ALX2 BARBEQUES - ROTISSERIE SPEAR SPACER RETROFIT KIT

SPIT ROD SPACER LOCATED PROPERLY IN THE REAR HOOD ASSEMBLY AFTER INSTALLATION

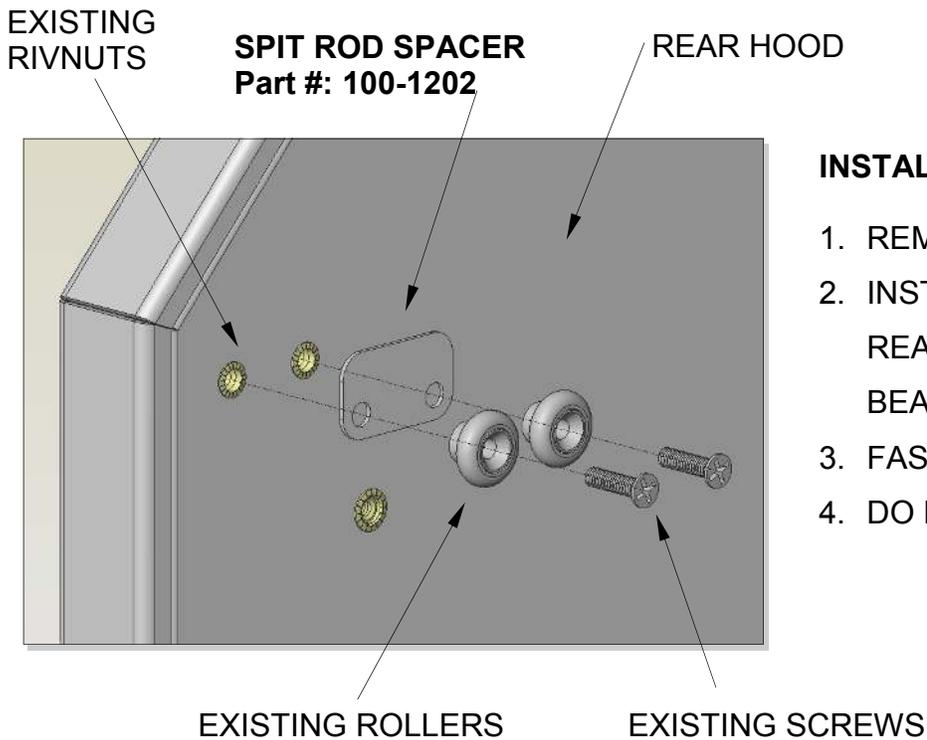
In order to adjust the spear's length to the unit to ensure a proper "ride" on the left side rollers and to properly lock into the right side rotisserie coupler, a STOP plate has been designed to shim the spear into the correct location within the unit.

Please install the SPIT ROD Spacer (Part # 100-1202) as shown on the following pictures:

1. REMOVE ROLLERS SCREWS
2. INSTALL SPIT ROD SPACER BETWEEN REAR HOOD WALL AND ROLLER BEARINGS.
3. FASTEN THE ASSEMBLY
4. DO NOT OVERTIGHTEN SCREWS.
